Form C-103  
Revised July 18, 2013

SUNDRY NOTICES AND REPORTS ON WELLS  
(DO NOT USE THIS FORM FOR PROPOSALS TO DRILL OR TO DEEPEN OR PLUG BACK TO A DIFFERENT RESERVOIR. USE "APPLICATION FOR PERMIT" (FORM C-101) FOR SUCH PROPOSALS.)

## Grynberg 14 State #1

Proposed Temp. Abandonment Plan in RED

Schematic and Temp Aband Plan in RED, 3/23/2018

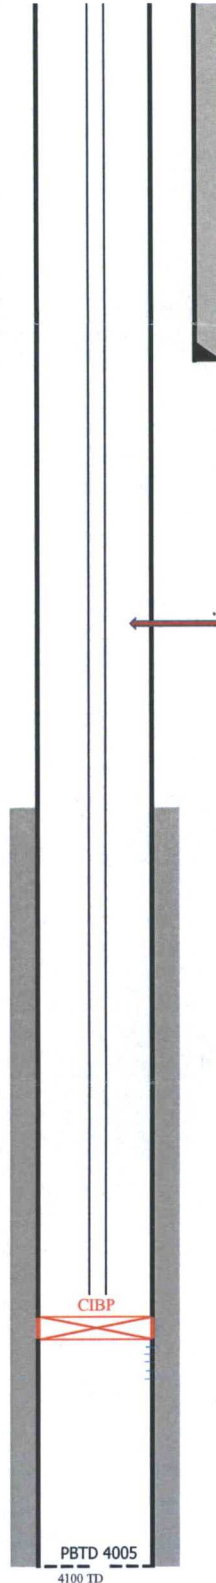
**DENIED - WELL HAS BEEN INACTIVE SINCE 8/1/2001.**  
**IT MUST BE RETURNED TO PRODUCTION OR RPA'd.**  
**RE - NMCD 4/25/18**  
RECEIVED  
APR 23 2018  
DISTRICT II-ARTESIA O.C.D.
